Department of Energy

The purpose of this letter is to report the Department of Energy's (DOE) closure of the electrical safety issues at our Plutonium Finishing Plant (PFP) and at Hanford tank farms identified in your September 17, 2008, letter to the Assistant Secretary for Environmental Management.

Richland Operations Office Plutonium Finishing Plant Closure Project

Electrical Safety DNFSB Briefing December 4, 2008 Matt McCormick, RL Kathleen Jennings-Mills, CHPRC

Hydrogen Accumulation Hazard in 2721-Z Standby Generator Room

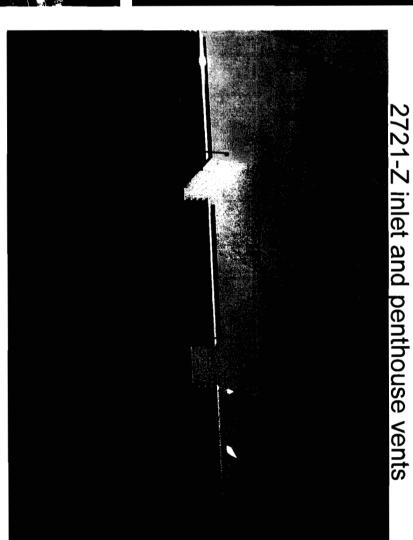
Concern: Open-filament space heater above lead-acid batteries in the diesel generator room. with the open filament of the space heater. An explosion could result if hydrogen of sufficient concentration were to come in contact

- Heating element maximum surface temperature is below Hydrogen autoignition temperature
- Survey of ventilation exchange rate, August 2008
- High passive exchange rate
- Ventilation pathways above heater elevation
- Low Hydrogen liberation from batteries
- Regularly scheduled checks of batteries (electrolyte, cell voltage, charging system, etc.) are conducted
- Micon annunciation upon charging system failure

Modifications are not needed to prevent accumulation of hydrogen in room 2721-Z.
